LIGO Review of ‘Compliance to LIGO Modification on GS-13’
LIGO C0900025-v1
Brian Lantz
Feb. 26, 2009

This is a review of the document ‘Compliance to LIGO Modifications on GS-13’ by David McClung of Geotech, dated Feb 23, 2009, for the modifications which LIGO requested for the GS-13s to be used for the Advanced LIGO HAM and BSC seismic isolation systems.

(drawing courtesy of Geotech)

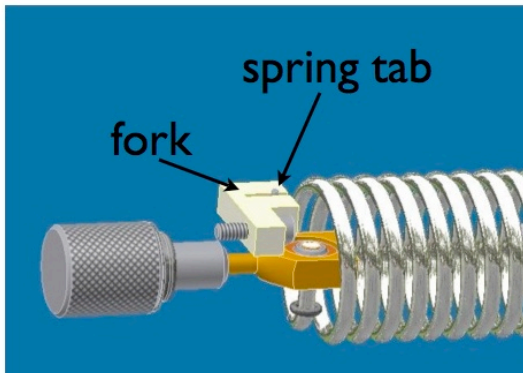
Inspection (c): NO, LIGO is referring to the tab shown below, which keeps the top of the spring from rotating as the tensioning knob is adjusted. For the vertical units, the tab should be in the slot. Note that since the horizontal units have neither the tab nor the fork, this inspection does not apply to the horizontal units.
